Item 6.**Development Application: 888 Bourke Street, Zetland**

File No.: D/2017/1723

Summary

Figure 24: Location of the subject boundary between the subject site and 5 O'Dea Avenue

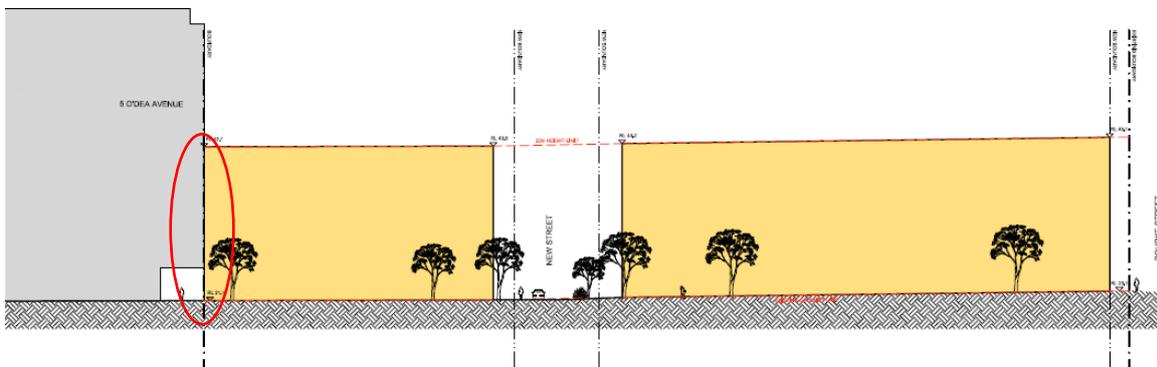
59. Building envelope B proposes a nil setback to the eastern boundary of the site where it adjoins 5 O'Dea Avenue. The existing residential flat building at 5 O'Dea Avenue is built right to the boundary and contains a number of windows located on the boundary. These windows provide light to habitable rooms for residential units. There is also a number of balconies with openings on the boundary (refer to Figure 24, 25 and 26 below).

64. A deferred commencement condition is recommended to require amended building envelope plans be submitted and approved by the Director of City Planning, Development and Transport showing the amended setbacks.

Figure 27: Indicative line to show building envelope setback 3m to avoid windows and balconies

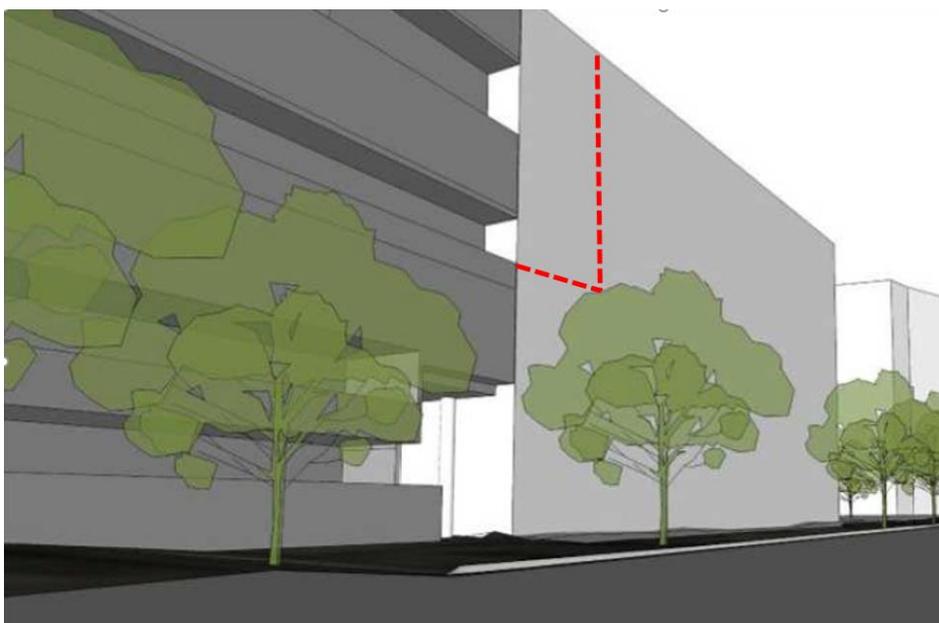
60. There is no easement or covenant registered on title of the subject site or the adjoining site to protect the subject windows or balconies. The subject windows are not discussed in the assessment report or conditions of consent for this completed development.
61. Notwithstanding this, it is not considered an acceptable outcome to allow the proposed building envelope to extend to the boundary, where a possible outcome could be that a future building could be built and totally obstruct these windows. This issue has been discussed with the applicant who has informally suggested that the building envelope should be permitted to the boundary for the lower levels where it will not impact these windows and could be setback from the boundary on the upper levels as not to impact the windows.

62. Staff have investigated this option and recommend the maximum envelope to be approved abutting the boundary up to RL 32.00 which is approximately 10.3m in height and must be setback 3m from the boundary for the levels above.

Figure 30: Sun's eye diagram of the proposed building envelopes with 6m upper floor setback at 11.30 am mid-winter

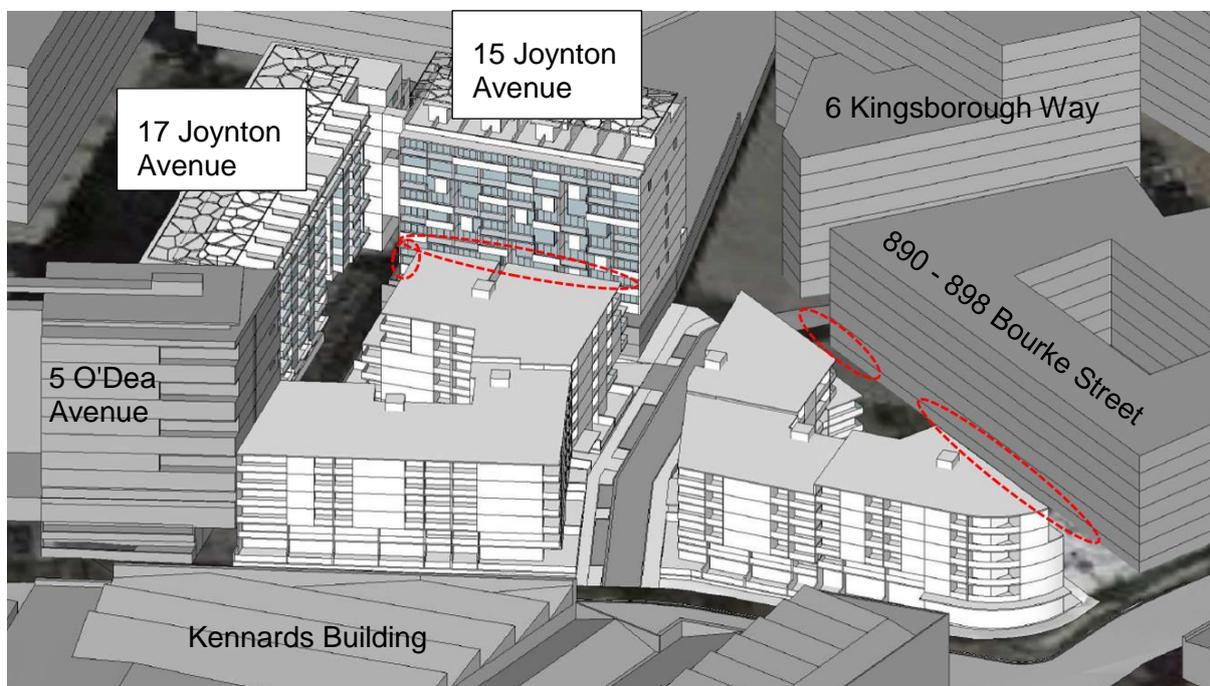
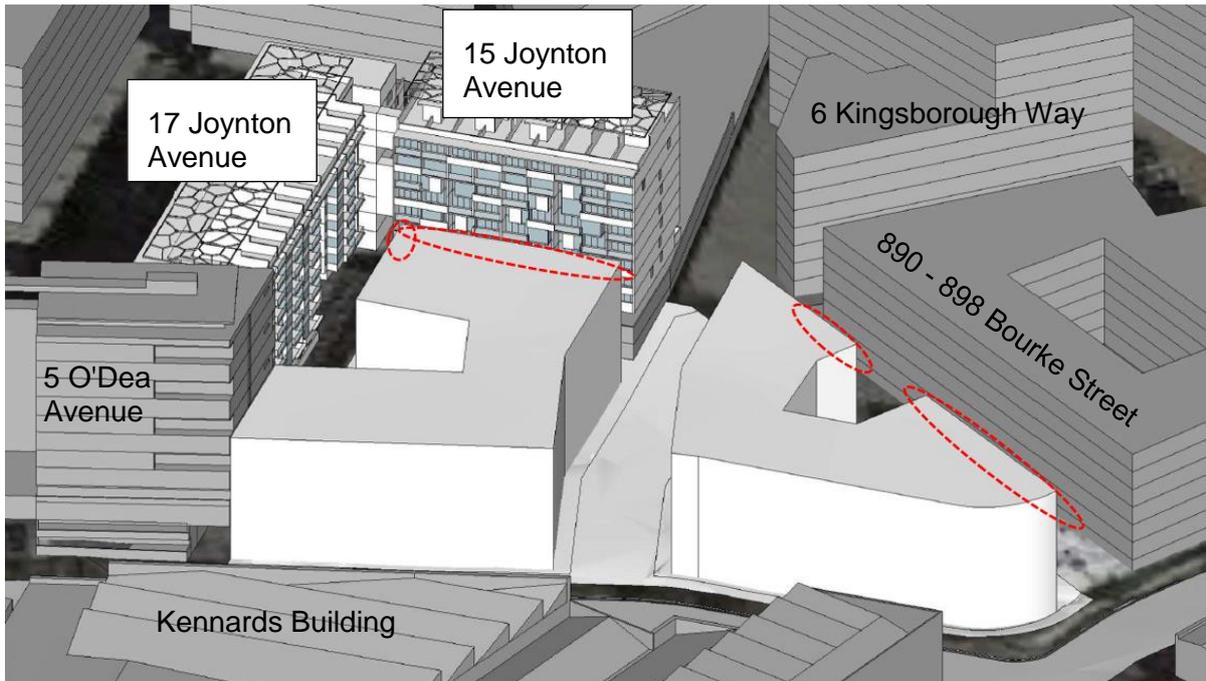
76. The submitted sun's eye diagram show the building envelopes as proposed have overshadowing impact on neighbouring properties at 15 and 17 Joynton Avenue and 890 - 898 Bourke Street.

77. When comparing the sun's eye diagram for the indicative scheme (which has the 9m upper floor setback), the adjoining development at 890 - 898 Bourke Street can receive 2 hours solar access for the entire northern eastern façade between 11.30am and 1.30pm mid-winter, in accordance with the ADG. Figure 29 below illustrates where additional solar access is received at 11.30am (circled in red) when compared to the proposed building envelope with a 6m side setback illustrated at Figure 30.

78. If the upper floors on levels 4 and 5 are setback 9 metres from the boundaries as recommended, the proposed envelope will have no impact on solar access to 890 Bourke Street after 11.30am, mid-winter.
